STAFF REPORT: 11/16/2022 REGULAR MEETING

APPLICATION NUMBER: #22-8094

ADDRESS: 19434 STRATFORD

SCOPE: INSTALL LANDSCAPE FEATURES, CONSTRUCT NEW DRIVEWAY (WORK DONE WITHOUT APPROVAL)

Figure 2, by Applicant: Proposed rear yard

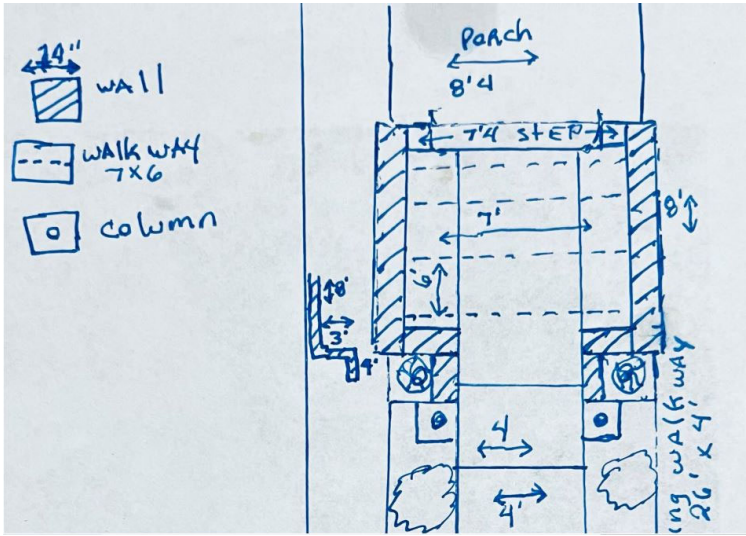
irrigated lawns with other materials, staff observed that the rear yard expansion of the driveway, **the garbage/recycling pad**, and turn-around greatly increases the amount of impervious paving surface that may affect the management stormwater run-off. (See Site Photo 6 and Figure 2.)

Figure 5, by Applicant: Proposed front walkway columns

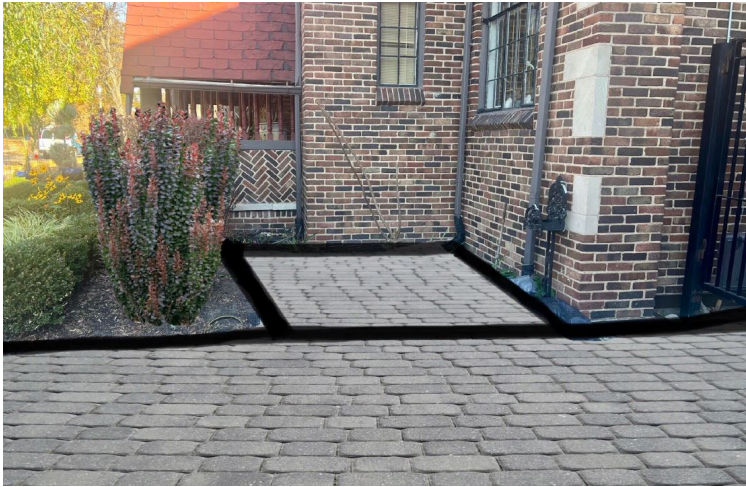
- It is staff's opinion that proposed front yard wall's design, concrete block materiality and scale detracts from the house's historic Tudor design. The Elements of Design describe the *Rhythm of Entrance and/or Porch Projects* as "entrance and porch types relate to the style of the building..." and it is staff's opinion

that the proposed design also does not meet Secretary of the Interior's Standards for Rehabilitation, specifically Standards 2, 5 and 9.

- The applicant work with staff to adjust the design of the driveway and walkway with the following changes:
 - Maintain the walkway's historic width.
 - Maintain the driveway to a width no wider than 10' until it approaches the garage, and then to be no wider than the garage itself.

Figure 6, by Applicant: Southwest corner of house, showing proposed garbage/recycling storage pad

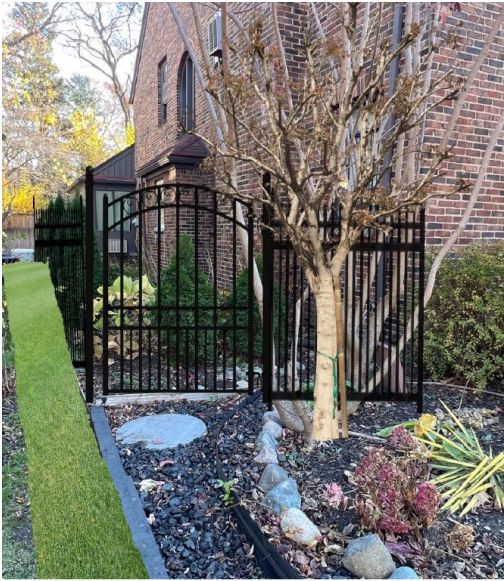
- **It is staff's opinion that the recent added concrete pad in the front yard is also inappropriate as the function for the use of storage of materials, even partially screened during a portion of the year, is not an appropriate location and would more readily be stored in the back yard, out of public view.**

Staff finds that the replacement of the original pathway and driveway with a single wider concrete driveway, the curbcut, **installation of the storage concrete pad in the front yard**, and the alteration of the front yard with the installation of the raised earth terrace and installation of the retaining wall destroys the historic character of this property and removes distinctive, character-defining features.

Site Photo 4, by staff, October 21, 2022: (West) extent of landscape and wood beams not secured in ground.

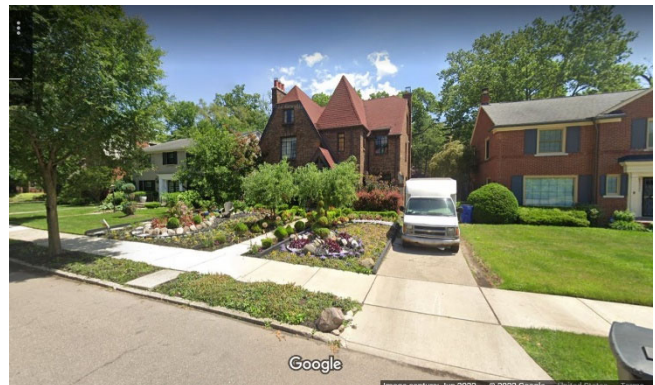
- Staff observed that the driveway was already removed, and grading work has begun to increase the width of the driveway footprint.
- Staff also observed that the front yard landscape planting has been complete for some time and observed that front yard, black-painted wood beams were not securely embedded in the ground both on the neighboring lot line and in the berm: there appears to be no footing or subsurface beams to keep the beams from heaving and lifting from the ground. (see Site photo 4)
